PLANNING AND DEVELOPMENT SERVICES STAFF REPORT

For Planning Commission Meeting of July 7, 2015

**SUBJECT: Rockbridge Hotel & Retail Rezoning and Planned Project Site Plan
File Nos. SP15-012 & Z15-003**

**SUBJECT: Rockbridge Hotel & Retail Rezoning and Planned Project Site Plan
(3201 South State Street)
File Nos. Z15-003 & SP15-012**

ROCKBRIDGE PROPERTY HOTEL
 REZONING AND PLANNED PROJECT SITE PLAN
 DIMENSIONAL SITE PLAN

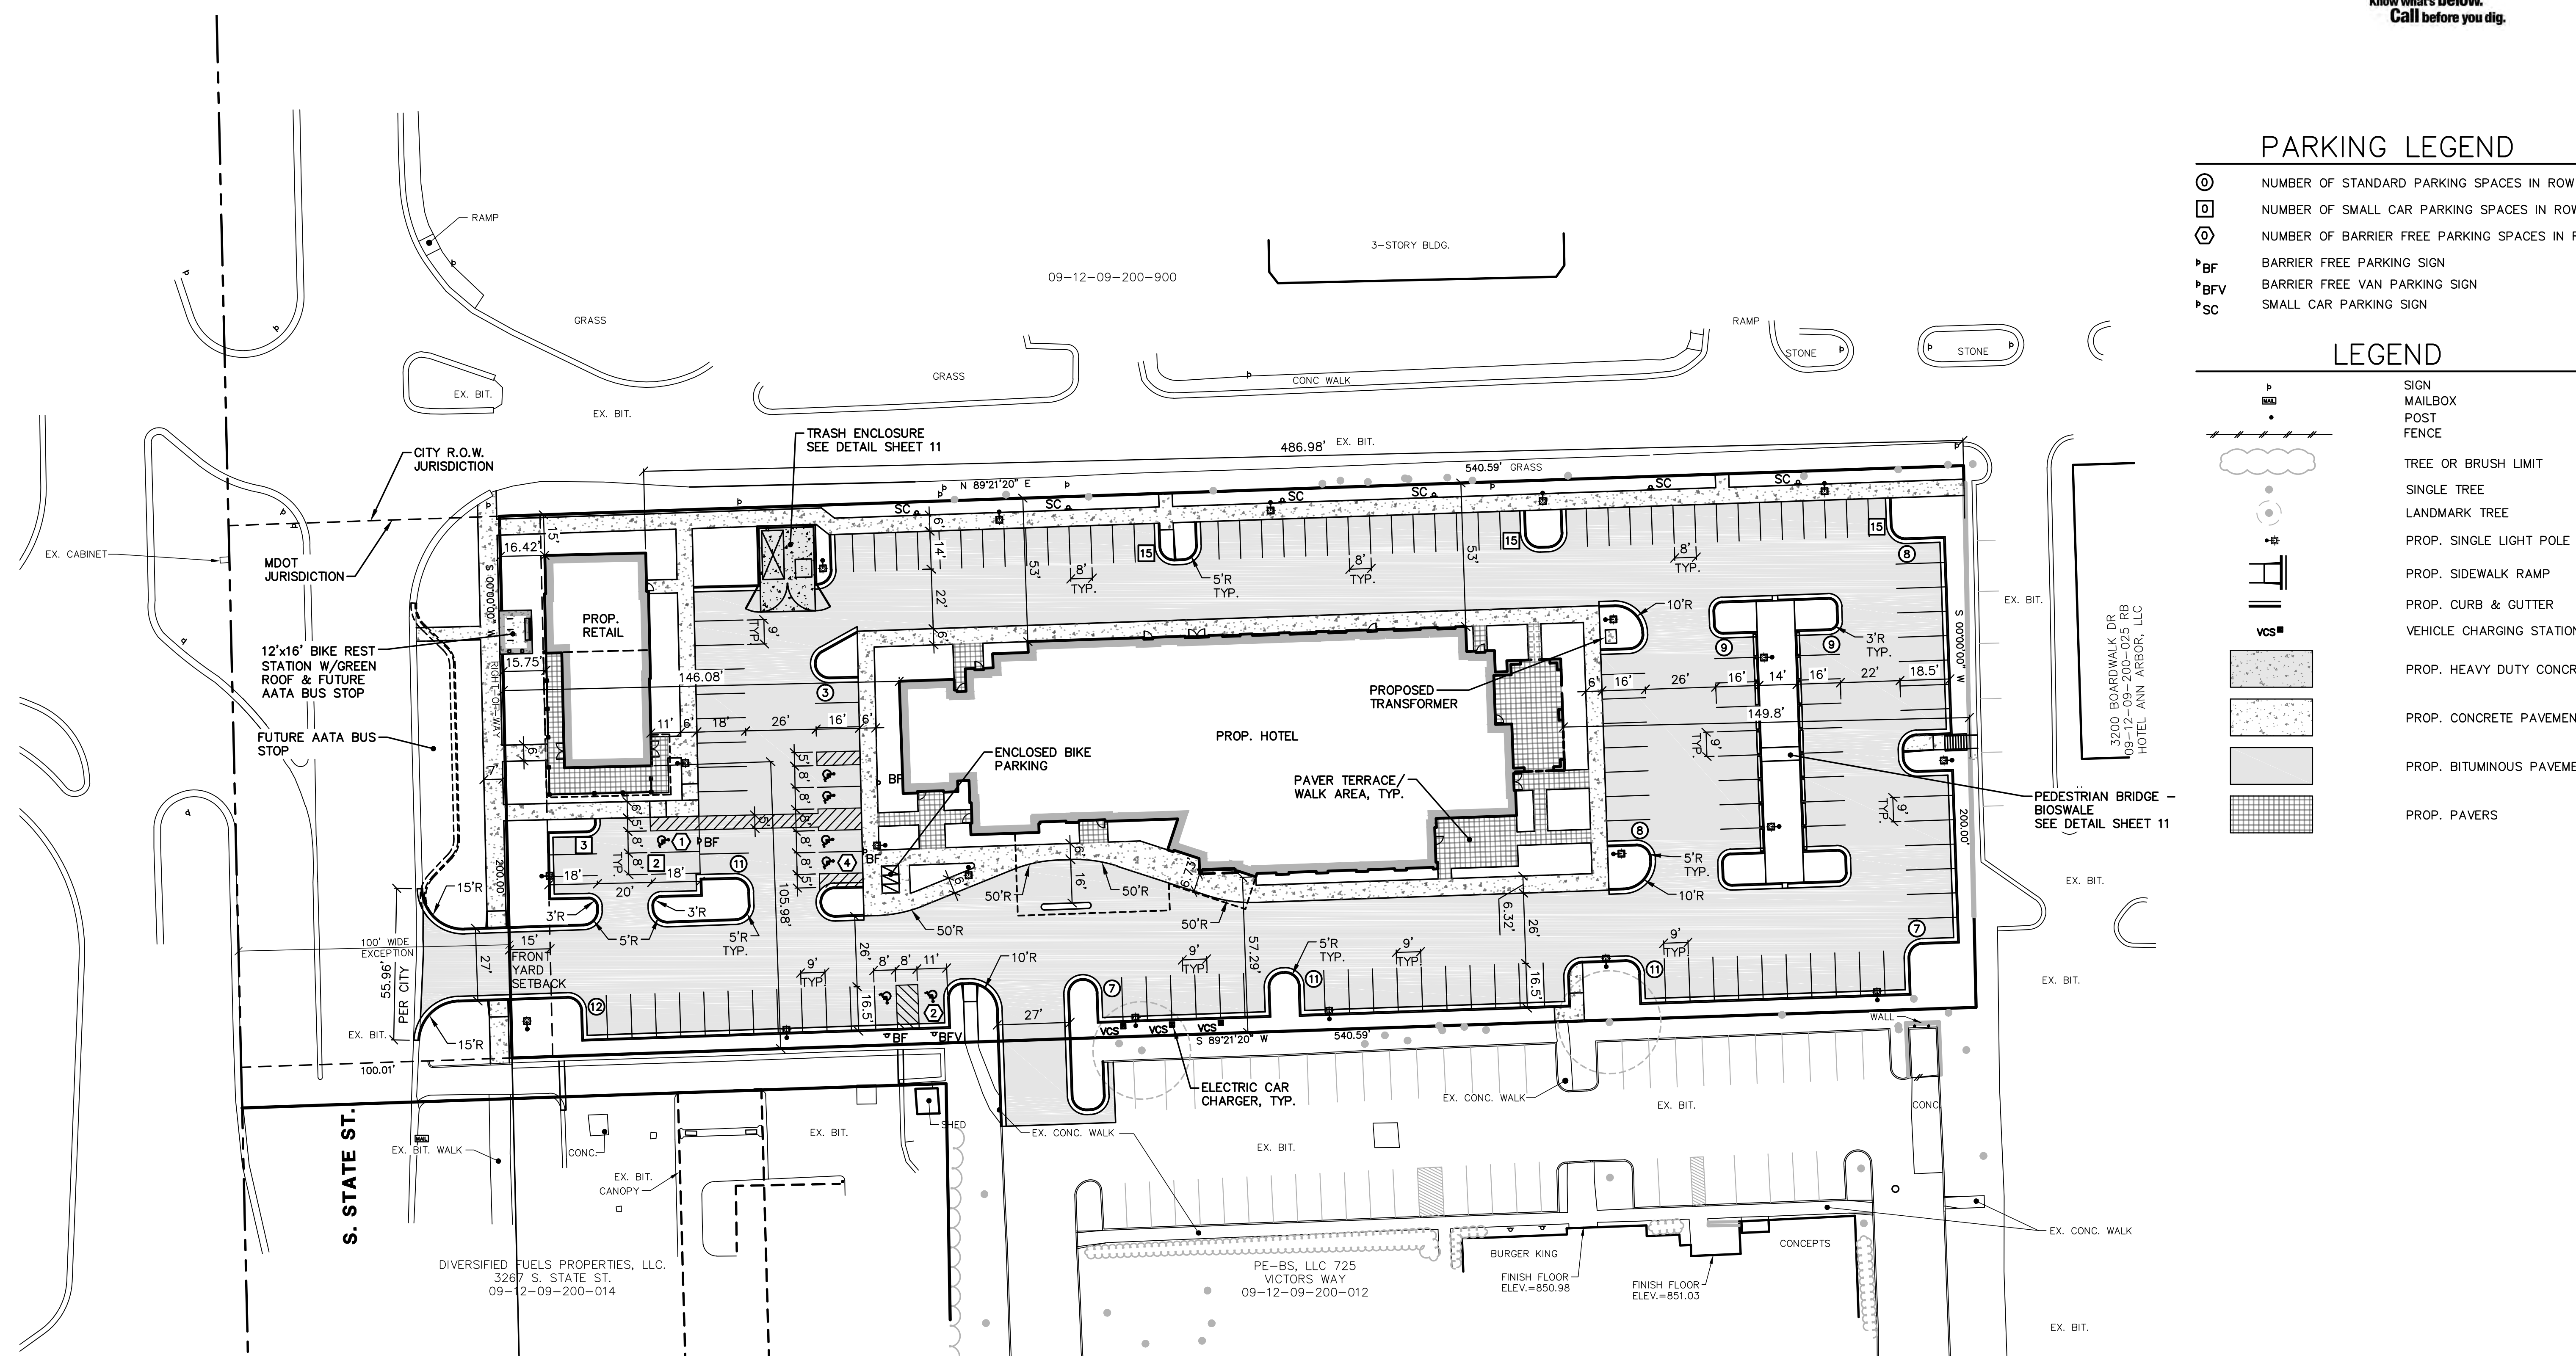
Sidewalk Installation

The sidewalk along the south side of the service drive fronting this site does not currently exist. The petitioner reduced the parking aisle width and installed a six-foot wide sidewalk along the service drive. Two additional non-landmark trees are proposed to be removed for the sidewalk installation. No mitigation is required for their removal.

Access to the site will be provided through an existing driveway off South State Street, which will lead to a driveway that loops around the hotel. Since the previous site plan submittal, the petitioner has entered into an agreement with the retail site to the south to make an internal vehicular connection between the two parking lots. This connection is located on the south side of the site and removes 6 parking spaces reducing the total amount of parking from 159 parking spaces to 153 spaces.

The Non-Motorized Plan and South State Street Corridor Plan recommend sidewalks on both sides of the service drive. The petitioner proposes a sidewalk along their service drive frontage and connected this site with the site to the south which improves traffic circulation.

SITE PLAN AND DIAGRAM | BIKE SHELTER/BUS STOP

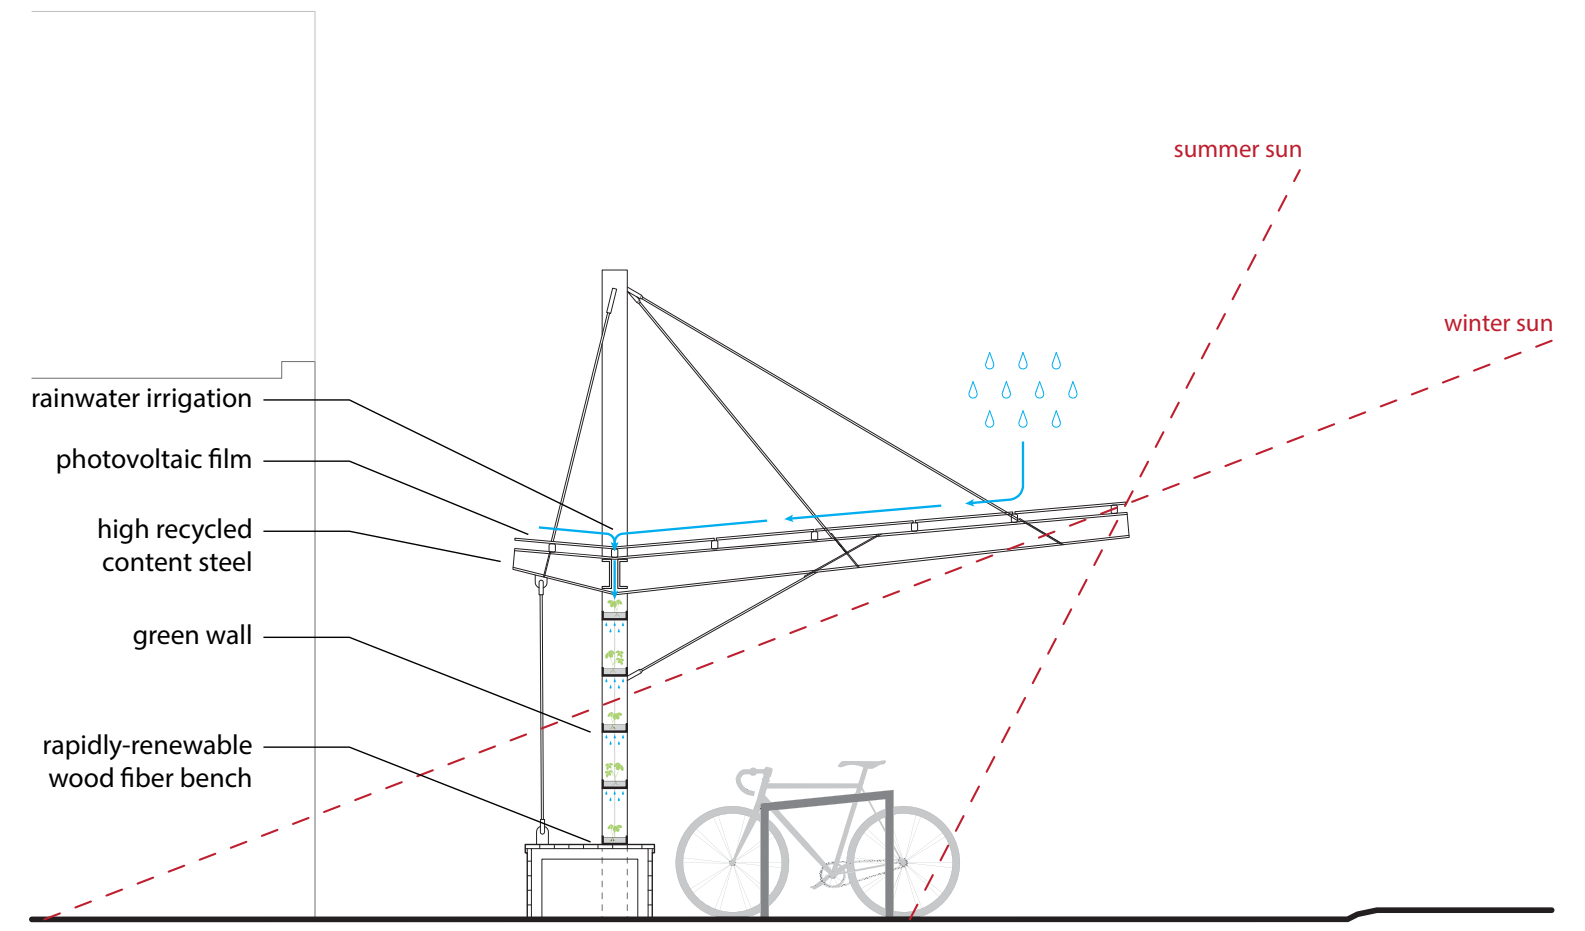
The bike/bus rest area has been revised to be more architecturally consistent with the site buildings, and the roof has been modified to show solar panels instead of green vegetation.
